MUN2017-01-11

Prolonging Time Between Overhaul of MAN Holeby L23/30H Mk. II

Fig. 1 The costs of spare parts for 6L23/30H Mk. II with TBOs at 16,000 and 20,000 hours, respectively.

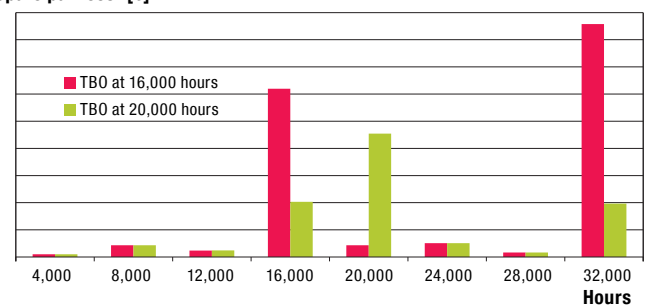
We have compared the costs of spare parts and man-hours for a 6L23/30H Mk. II when applying TBOs at 16,000 and 20,000 hours, respectively. The outcome of the comparison is that prolonging the TBO of L23/30H Mk. II (720 r/min) from 16,000 hours to 20,000 hours will provide the owner with a reduction in spare part costs of 40% and a reduction in necessary man-hours of 22% per GenSet, see. Fig. 1.
